AGENDA
PLANNING AND ZONING COMMISSION MEETING
CITY OF CREVE COEUR, MISSOURI
MONDAY, DECEMBER 17, 2018
6:30 PM

**APPLICATION TO PLANNING AND ZONING COMMISSION
#18-047 FOR A MINOR SITE PLAN FOR THE SCULPTURE AND
PLAZA AREA AT CHAMINADE COLLEGE PREPARATORY SCHOOL**

APPLICATION TO PLANNING AND ZONING COMMISSION #18-049 FOR A MINOR SITE PLAN APPROVAL FOR THE EXTERIOR MODIFICATION TO THE BUILDING AND NEW LED PARKING LOT LIGHTING AT THE FORMER HBE BUILDING

Figure 1: Image of a proposed sculpture Christ the Teacher and the limestone base detail.

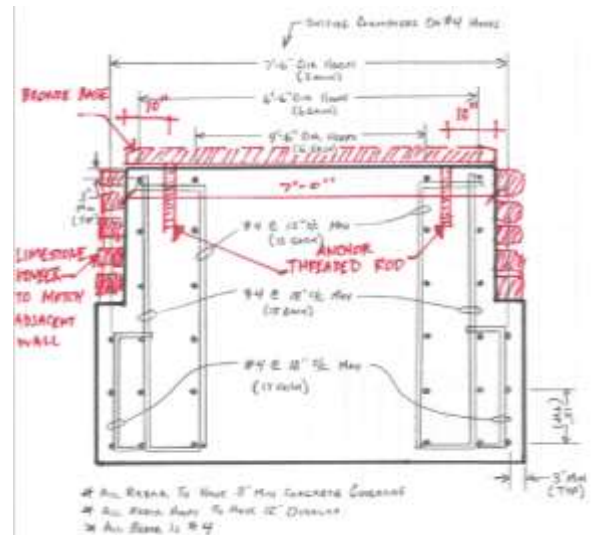
The low wall appears to consist of brick to match the existing building and to serve as more of an architectural feature to highlight the sculpture and plaza space. The overall height was not indicated, nor the architectural detail provided, therefore Staff has included a condition of approval that the Applicant shall submit for a building permit for the wall and provide additional detail and that the overall height shall not be more than four feet.

3. The sidewalks and walkways shall be a minimum of 6 feet in width in compliance with Section 405.730 Sidewalks.
4. The architectural wall shall be a maximum height of four feet, and design detail shall be submitted with the building permit for the Zoning Administrator's approval.

Figure 4: Close-up of the Plaza area with the new sidewalks/walkways to and around the sculpture.

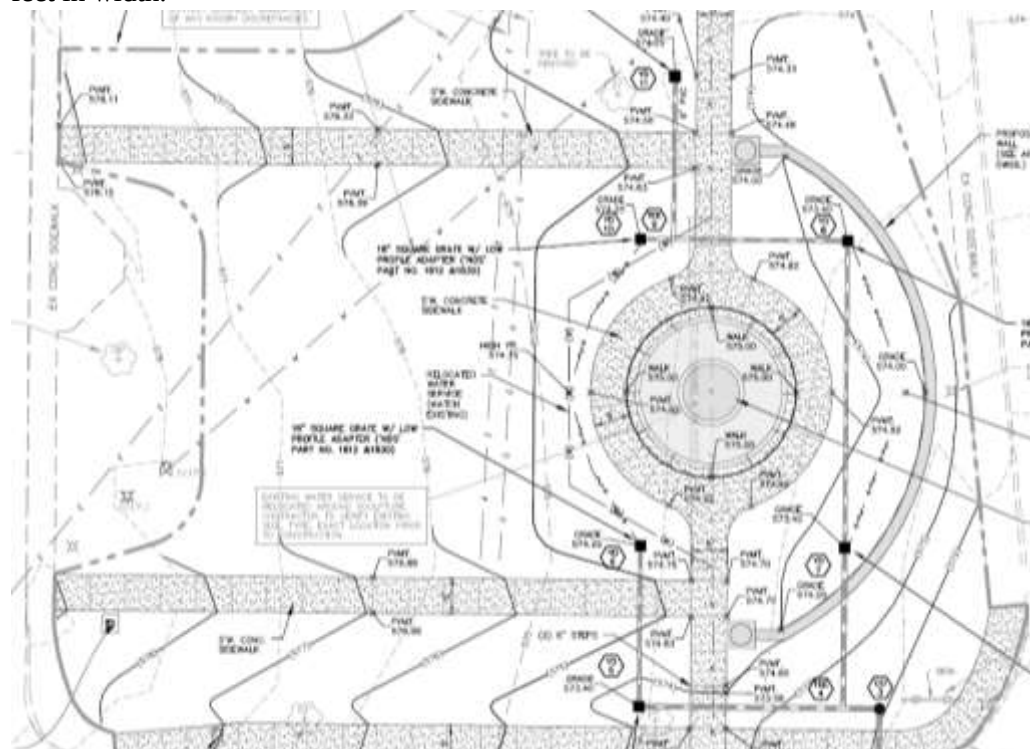
The proposal includes new walkways to and around the sculpture. The drawings indicate that these walkways will tie into the existing that are surrounding the lawn area, however they are at 5 feet in width. Section 405.730 Sidewalks requires that the minimum width of internal sidewalks in non-residential developments shall be at least six (6) feet or eight (8) feet if used as a curb stop. Therefore, Staff has included a condition of approval that the walkways to and around the sculpture shall be a minimum of 6 feet in width.

Figure 1: Applicants rendering and photo of new entrance design.

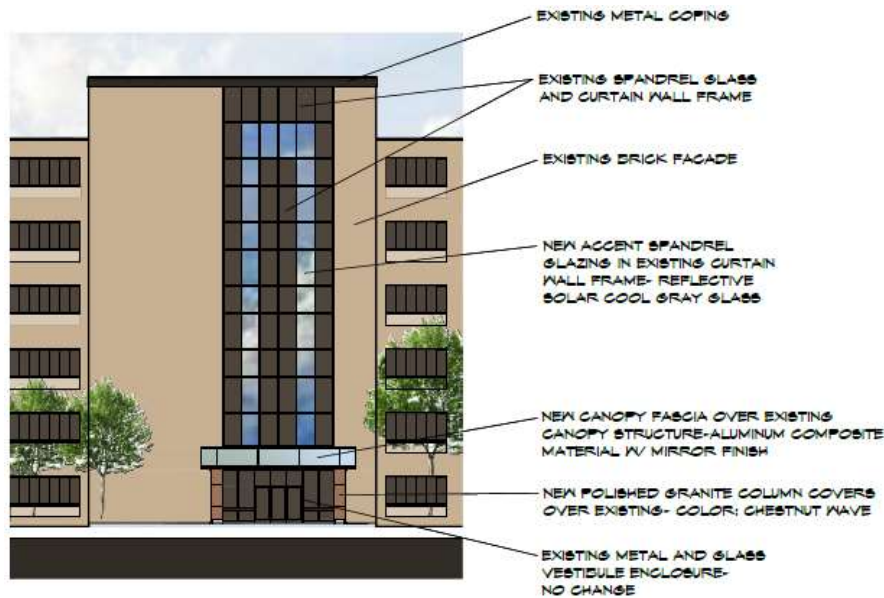
The original building was developed in 1979 as an office building, and is pre-existing non-conforming to the current ordinance. The Applicants revised the main entrance to include canopy fascia with an aluminum composite material with a mirror finish, granite columns, and new spandrel glazing with reflective material on the central window element of the building, to mimic the mirror finish of the canopy.
